AMENDMENTS TO THE DRAWINGS

REMARKS

FIG. 1

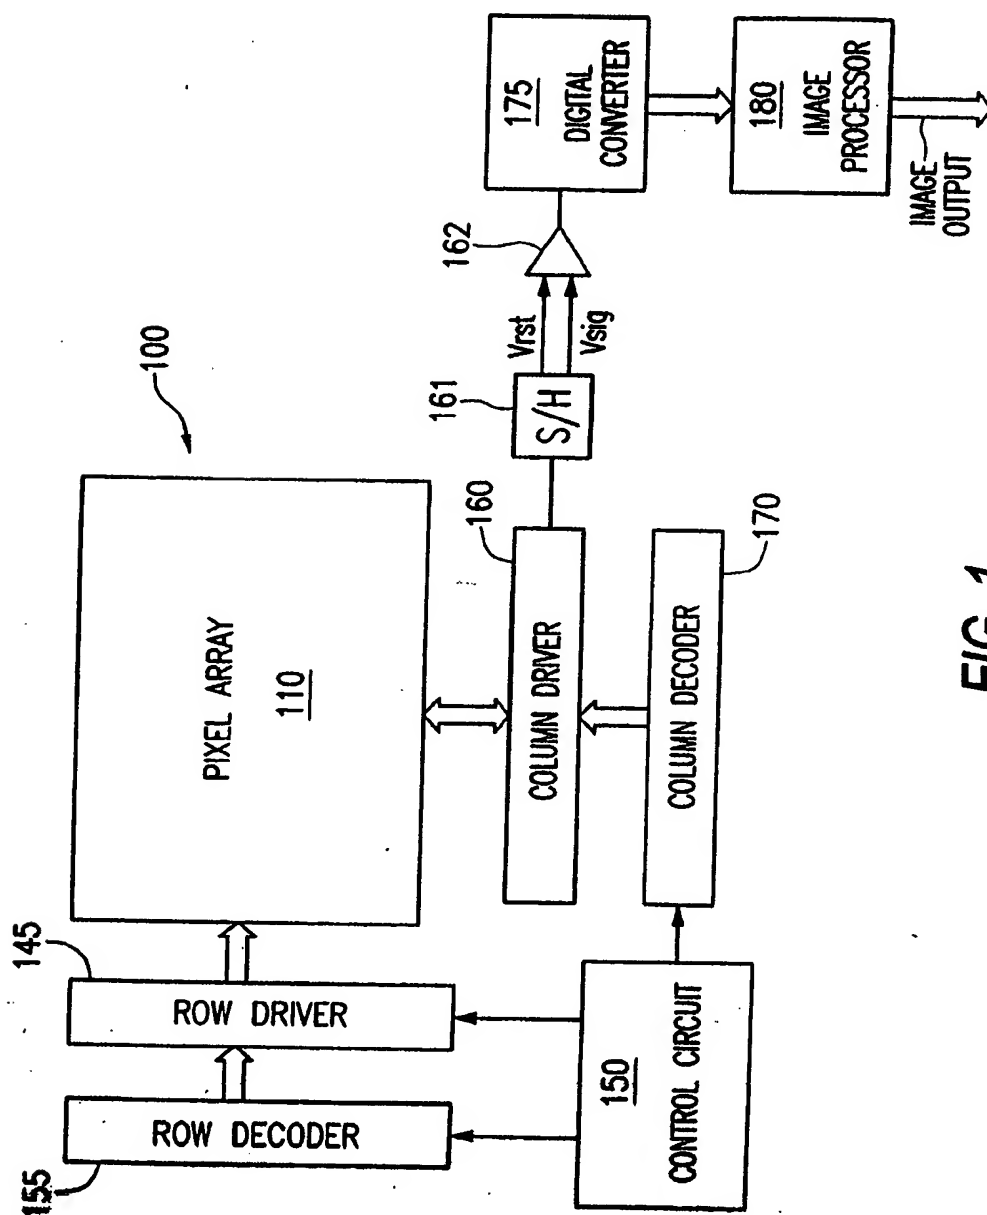
Figures 1 and 2 stand objected to as failing to comply with 37 CFR 1.84(p)(4) and (5). Figures 1 and 2 have been revised to indicate that they are prior art and Figure 2 has been revised to re-label the row select transistor with reference character "36." Applicant submits that the figures are in compliance with 37 CFR 1.84. In light of this revision, Applicant respectfully requests that the objection to the figures be withdrawn.

ANNOTATED SHEET SHOWING CHANGE

(PRIOR ART)
